Remediation Working Plan (Addendum 26/11/2019)

This document has been compiled to address a request for further information (Natural Resources Wales to VertaseFLI on 26th November 2019), in relation to the application for a Discharge Permit (NRW Ref: PAN-007572).

Figure 2. Carbon Swap-Out Procedure

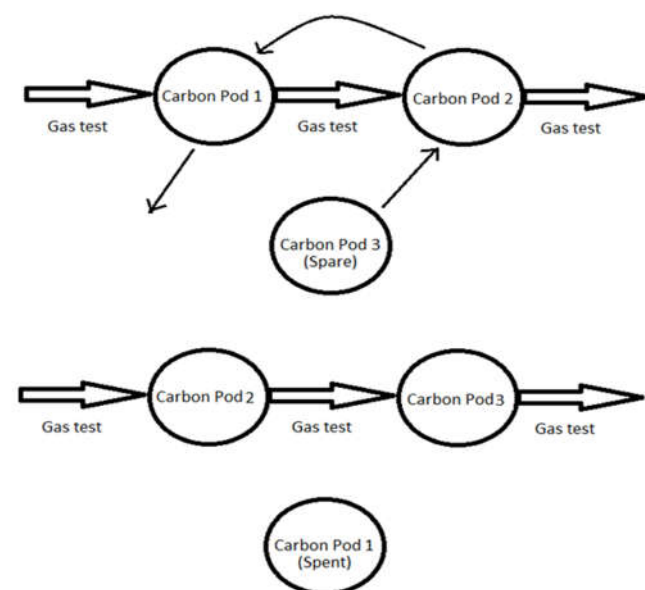
- If a detection of any substance above the MRV is found what mitigation will be in place to ensure no hazardous substances are discharged?
- Can you confirm that the infiltration system in place will ensure there is no discharge of liquid effluent directly to groundwater?

The proposed method of replacing activated carbon would be to swap the vessels with fresh ones. This means it would be straightforward to replace with increased capacity vessels to manage the frequency of change outs required.

The method of change out is shown in Figure 2. below.

Weekly water sampling will be undertaken before, between and after the carbon pods, during commissioning and initial operational phases to establish that the system is working as intended. Sampling will then be undertaken (in the same location) in line with the maintenance regime with declining inlet concentrations as the remediation progresses.

Sampling for hazardous substances, at a limit of detection at or below the MRV, will be undertaken. Should breakthrough occur (hazardous substances detected at, or greater than the MRV) after the first carbon pod, swap-out will be undertaken.

This will ensure there will be no detections of hazardous substances above the MRV's throughout the duration of the project at the point of discharge. The sampling, post 2nd carbon pod, will confirm this.

The presence of the second carbon pod should be considered as the insurance or mitigation in place to ensure no hazardous substances are discharged.

Title: GROUNDWATER ABSTRACTION
& WATER TREATMENT SYSTEM P&ID

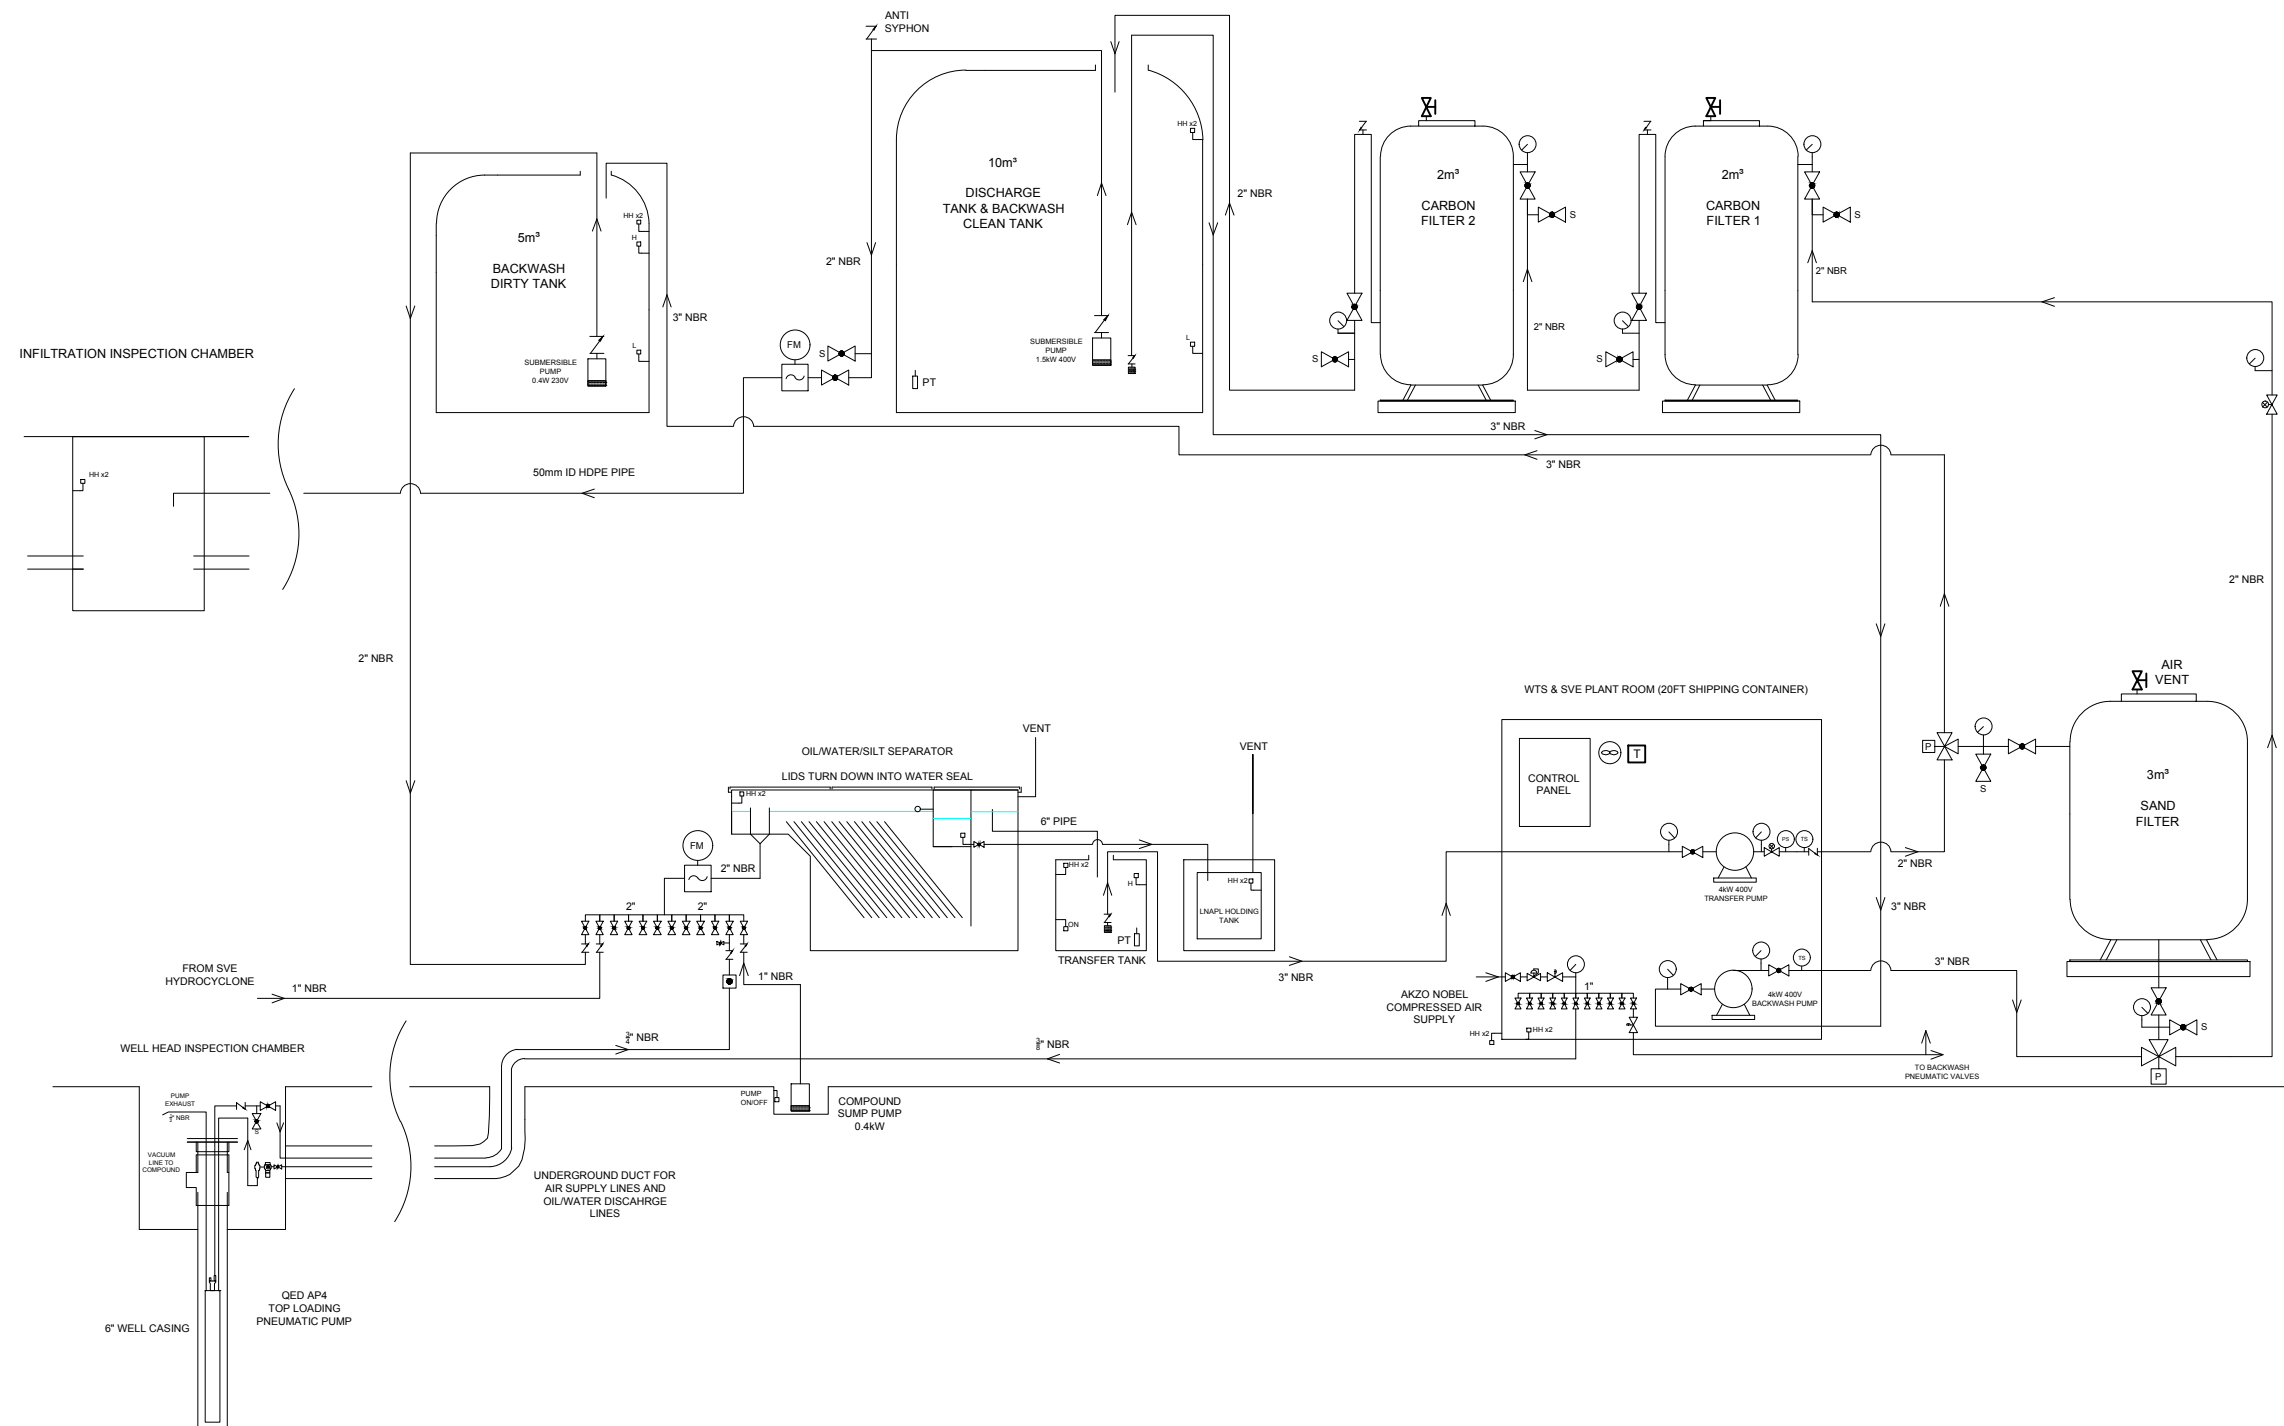
- Will the proposed remediation technique ensure for the duration of the discharge that these limits we be able to be met?
- Please can you provide a sampling/monitoring routine which specifically outlines how you will ensure there will be no detections of hazardous substances above the MRV's throughout the duration of the project?

Drawings 1828_01 and 1828_03 (Appendix A) show the site layout and groundwater treatment process respectively.

Total fluids will be delivered to the water treatment plant by way of pneumatic top loader pumps.

The total design treatment capacity for the groundwater treatment system is 150m³/day or 6.25m³/hr.

- 20ft plant room container comprising control panel, backwash & transfer pumps, pneumatic pumps' manifolds and dosing pump, if required;
- Oil/water/silt separator (OWSS);
- LNAPL holding tank (to HSG176);
- 3m³ sand filter;
- Two 2m³ carbon vessels (for water treatment installed in series);
- 5m³ backwash/dirty tank;
- 10m³ discharge tank/backwash clean tank; and
- Two flow meters, one positioned at manifold outlet and one positioned on effluent discharge outlet.
